Date: MAR 09 2016
Symbol: EPC-DO-16-056
LA-UR: 16-21078
Locates Action No.: N/A

Subject: Transmittal of Class 1 Permit Modification Notification to Update Figures in the Los Alamos National Laboratory (LANL) Hazardous Waste Facility Permit, EPA ID No. NM0890010515

**Class 1 Permit Modification Structure Changes at Technical
Area 54**

Figure 35
 Technical Area (TA)-54, Area G, Building 33

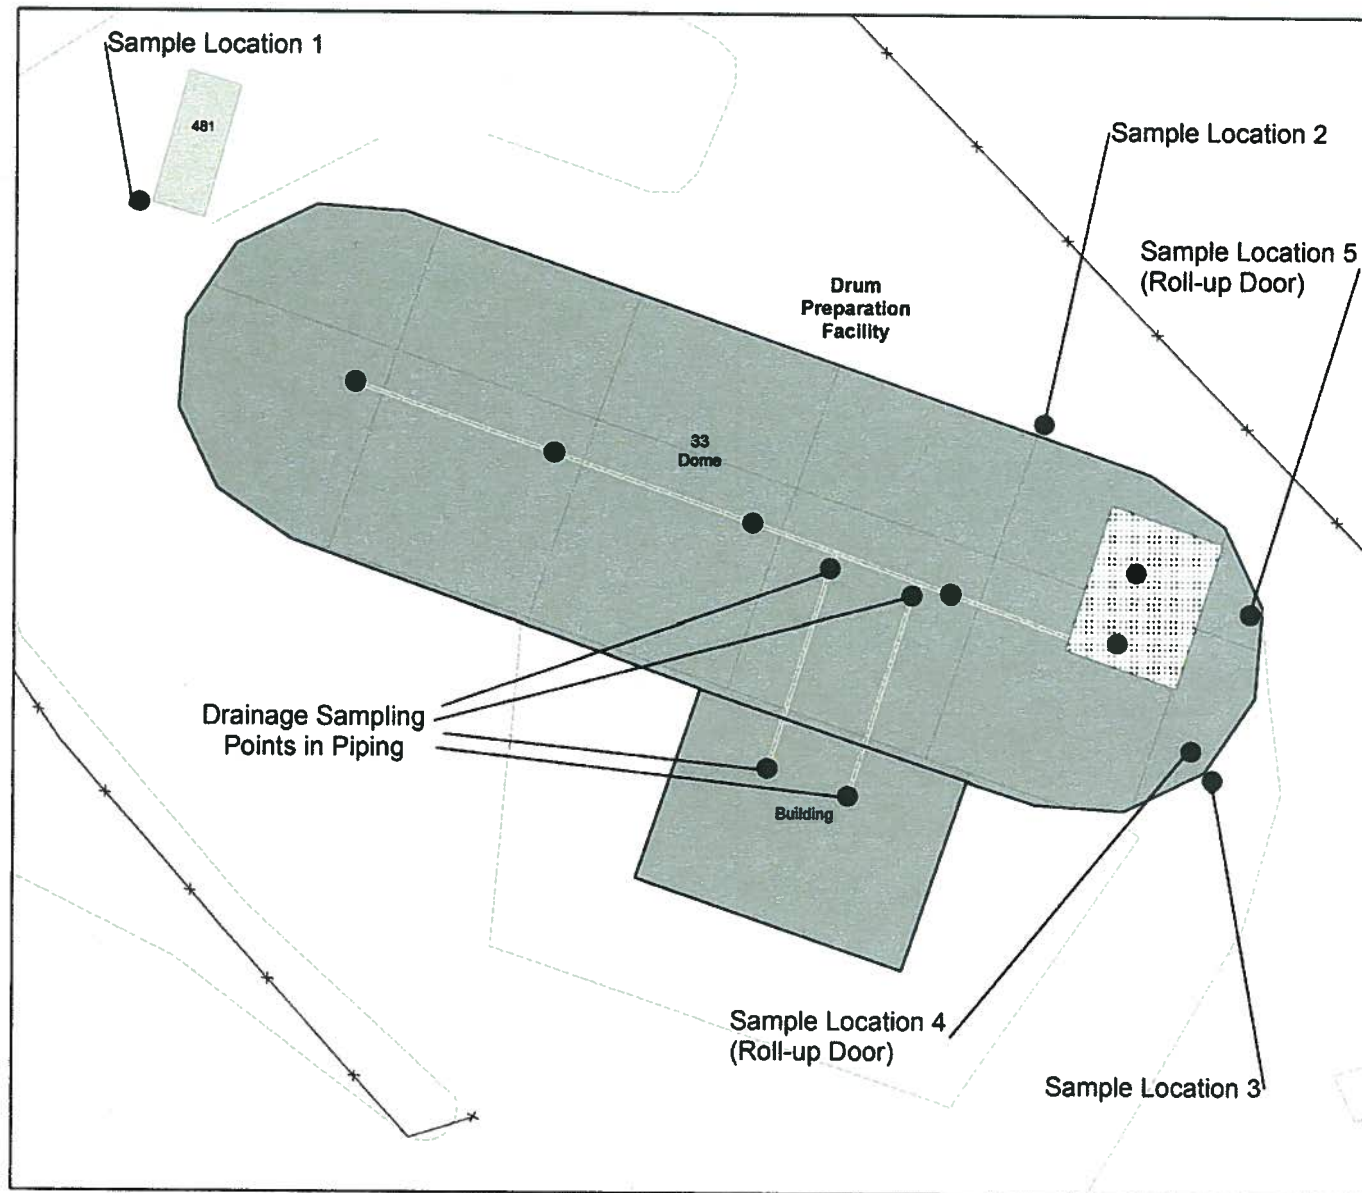
Figure 35 (Technical Area (TA)-54 Area G, Building 33) of Attachment N and Figure G.14-1 (Technical Area 54, Area G, Building 33, Indoor Container Storage Unit Grid Sampling and Additional Sampling Locations) of Attachment G.14 were revised to remove structure 377. This structure, which was relocated to Pad 1 to serve as a storage structure, is not associated with Permit activities or the management of hazardous waste.

Figure 27: Technical Area 54, Area G, Container Storage Units

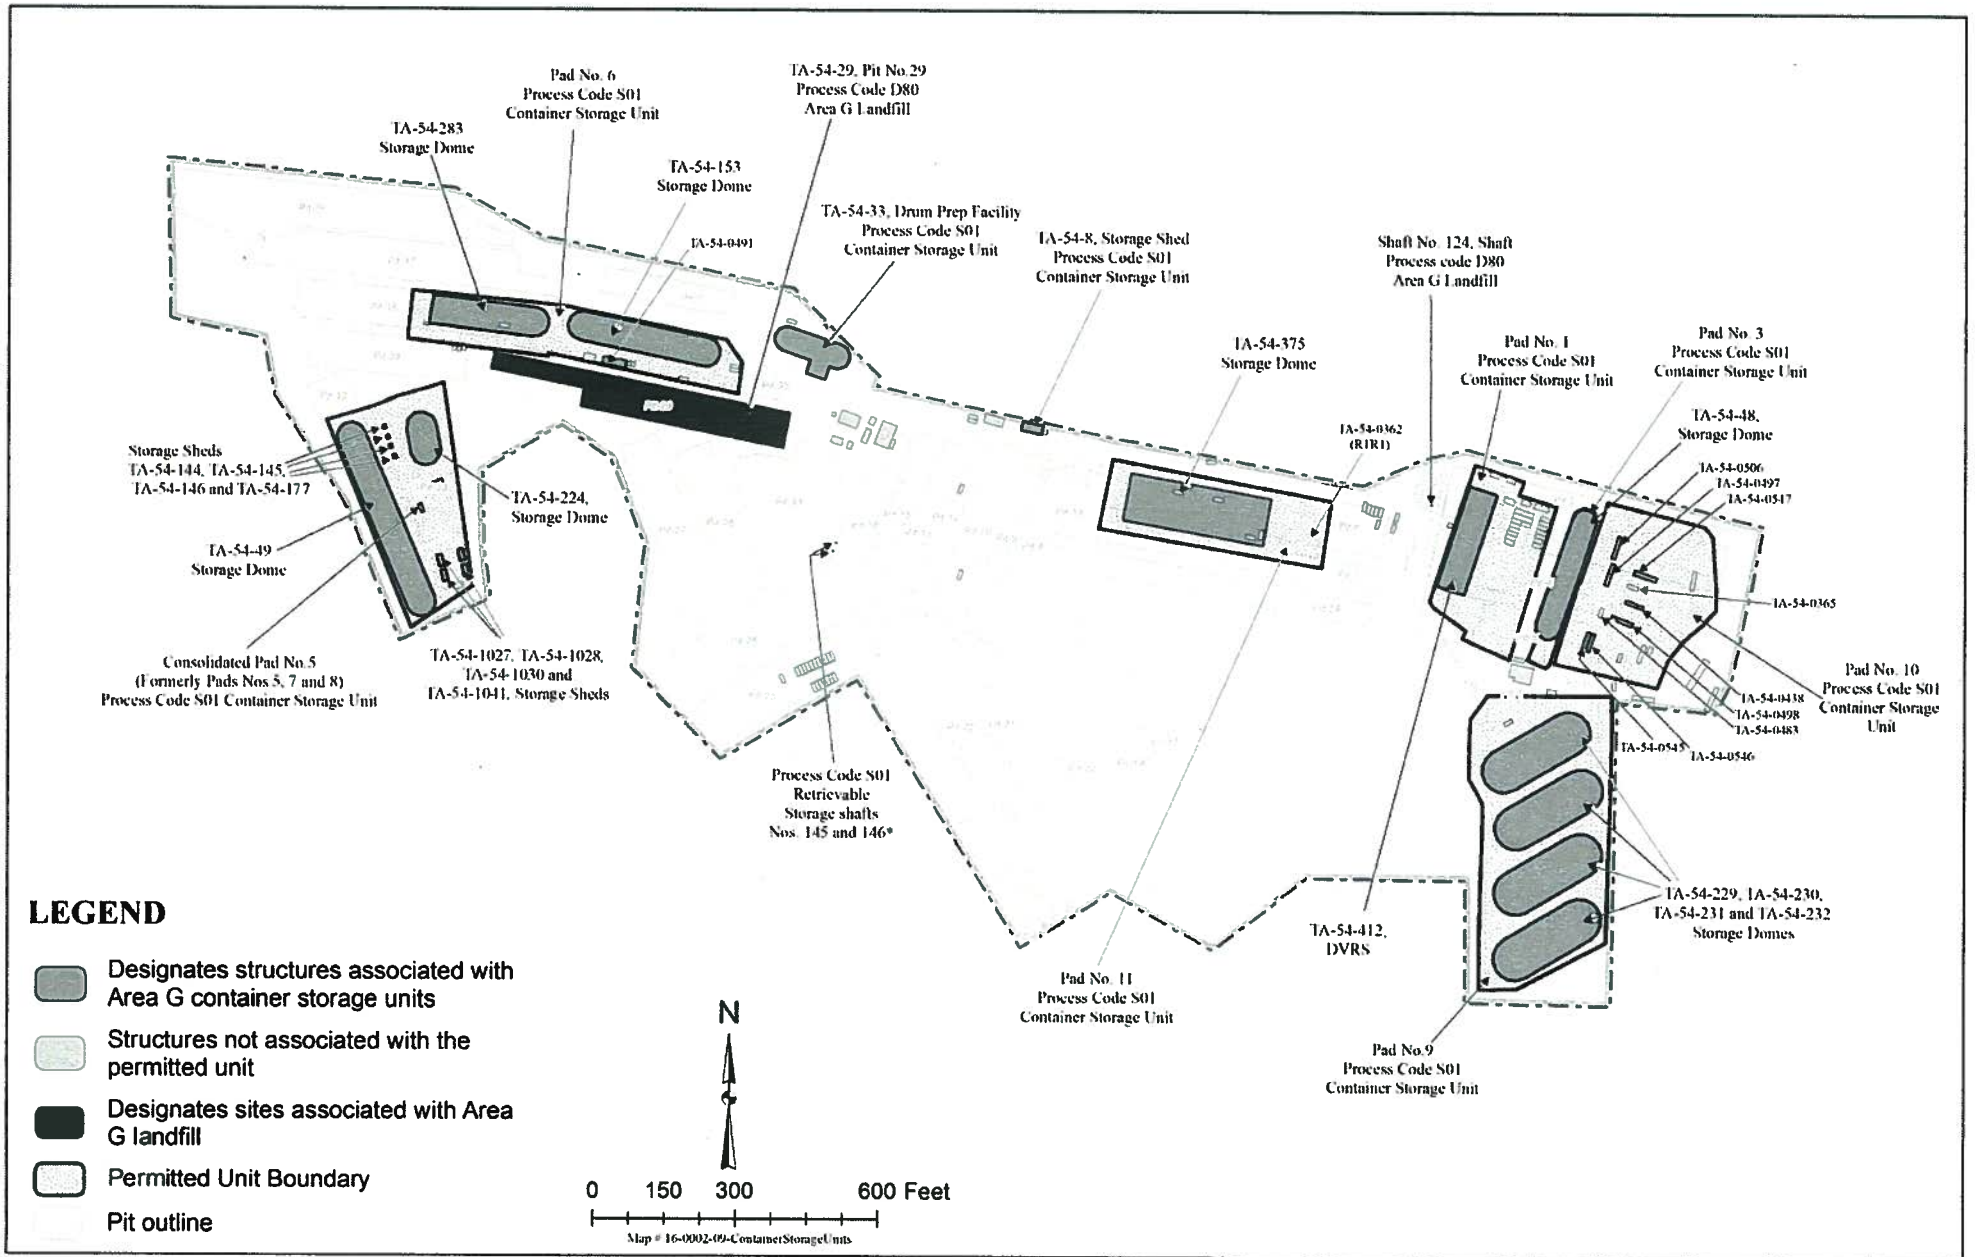
Figure 27 (Technical Area 54, Area G, Container Storage Units) of Attachment N was revised to reflect all of the changes discussed above and remain consistent with other figure updates. The changes to Figure 27 are as follows:

- On Pad 1, seventeen support structures were moved to the Pad. These structures will be used to store equipment and tools; they are not associated with the permitted unit and they will not be used to manage hazardous waste.
- On Pad 10, storage trailer TA54-1059 was removed and relocated to Pad 1. Storage trailer (54-484) and two additional support structures, which will be used to store equipment and supplies, were moved to the south east corner of Pad 10. These structures are not associated with the permitted unit and are not used to manage hazardous waste.
- On Pad 9, storage shed 574 was removed and relocated to Pad 1.
- Near Building 33, storage trailer 377 was removed and relocated to Pad 1.
